0.0	
Submission for	
Carlingford West Public School Upgrades	
Construction and refurbishment of permanent learning spaces, new library, reconfigured open space, access and play areas. Also includes construction of additional parking spaces on site, new driveway and turning circle to Felton Road west.	
0.1	
Project Details	
Application Number: SSD-10879802	
Assessment Type: State Significant Development	
Development Type: Educational establishments	
Local Government Areas: City of Parramatta	
0.2	
Submission by	
Adam Lee	
Architects Registration Board NSW 8579	
Secretary, P&C Executive Committee, CWPS	
26 July 2021

3.2**Possible solution #2**

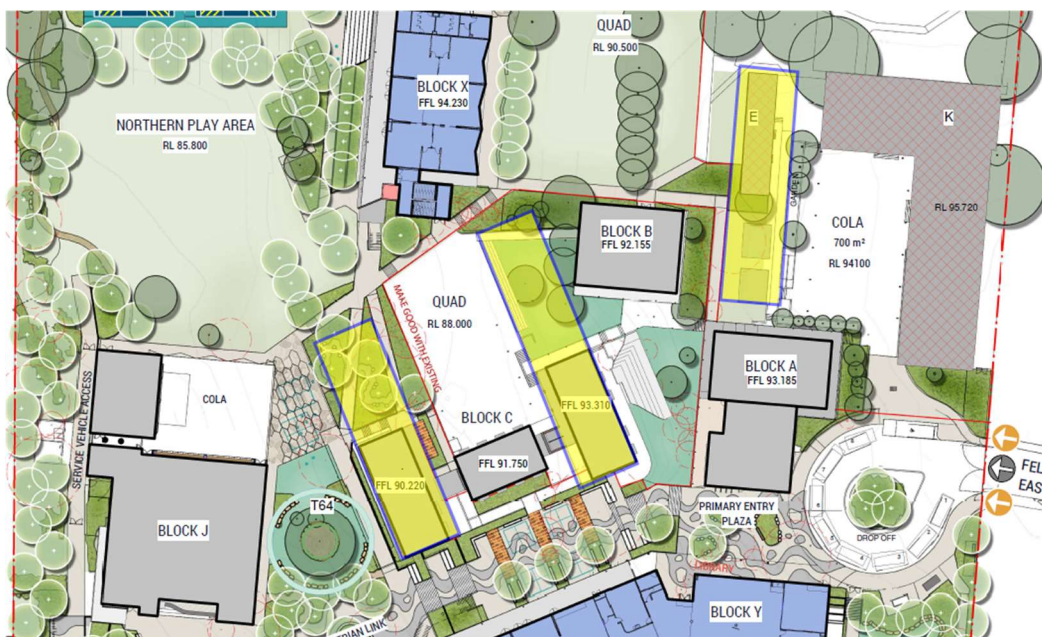
Create more learning spaces by adding a floor to Building Y. That is, instead of 3 levels above ground level, there will be 4 levels to the major wing. The library wing remains as 3 levels. The addition of floor space and building height has less impact to the neighbouring properties in comparison to Block X and other proposed or existing buildings.

The downside of this solution is the increase in cost and construction duration.

In terms of cost increase, value engineering is required on items such as mechanical system, civil works, finishes and FFE schedules.

In terms of duration increase, modular components are recommended.

3.3**Possible solution #3**

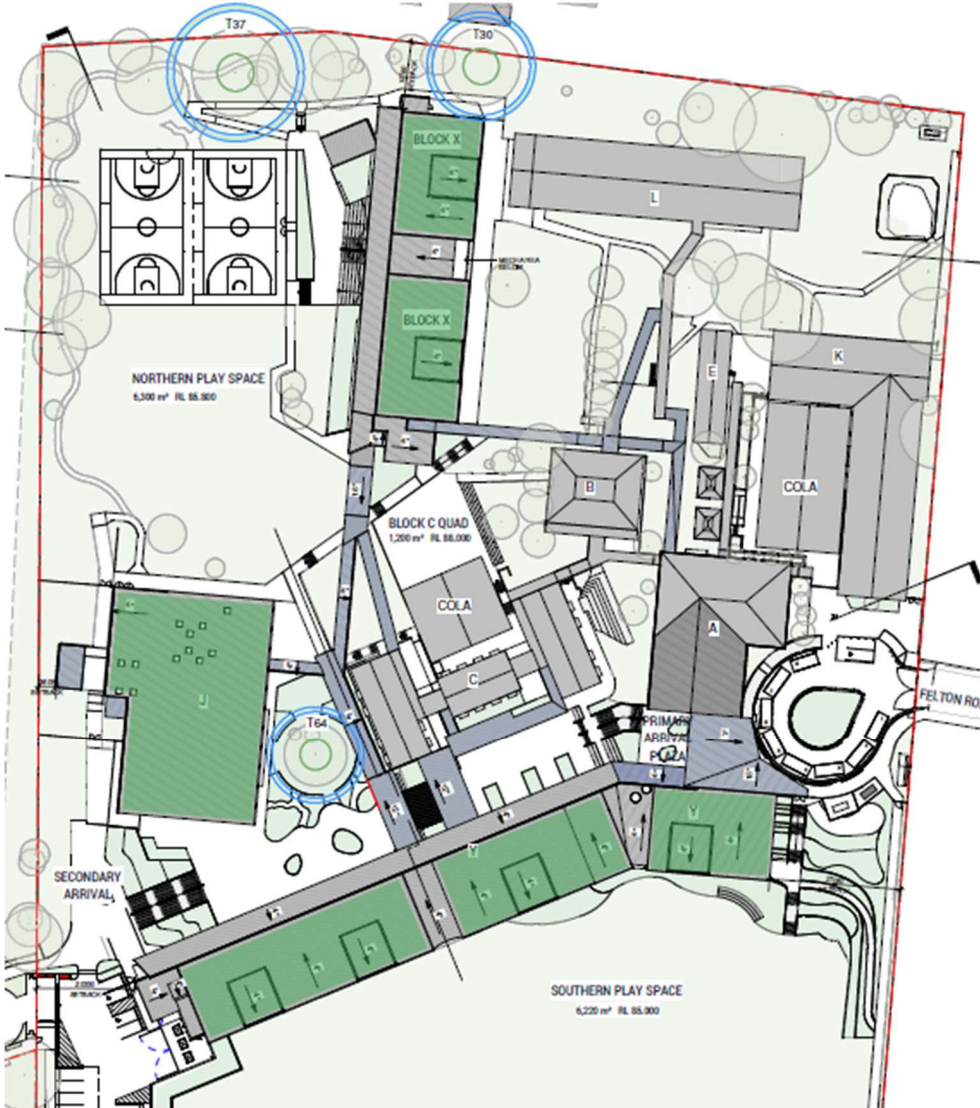
More learning spaces can be created by modification and extension to Block C and E, inclusive of reinstating the amenities within. The addition will mean a decrease in minor open spaces, not affect major open spaces for students.

This is not part of the SSD application; hence, Block C and E belongs to the exempt development and/or CDC applications.

Downside of this solution is that the learning spaces created are different to the modular home base unit offered in Block X and Y.

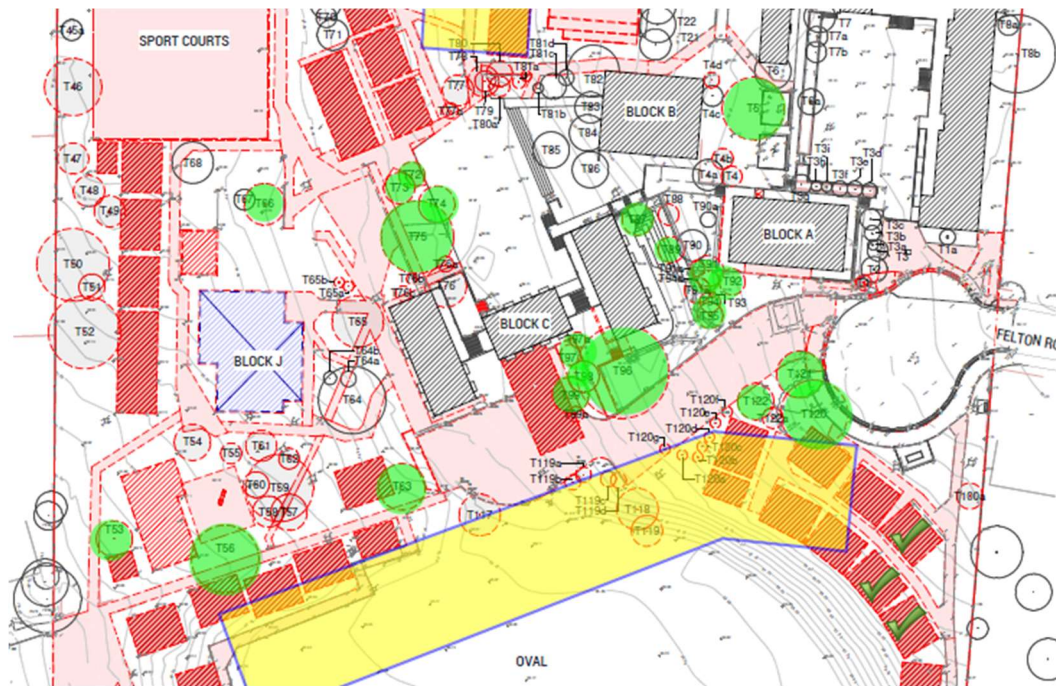
Existing T56 of “High Retention Value” to the south of Block J can be retained by integrating into the new landscape design.

Existing T75 of “Moderate-High Retention Value” to the north of Block C can be retained by integrating into the new landscape design.

Existing group T87, T89, T91, T91a, T92, T93, T94 and T95 in between Block A and C can be retained by integrating into the new landscape design.

Existing T66 of “Moderate-High Retention Value” to the north of Block J can be retained by integrating into the new landscape design.

Existing T5 of “Moderate Retention Value” to the east of Block B can be retained by integrating into the new landscape design.
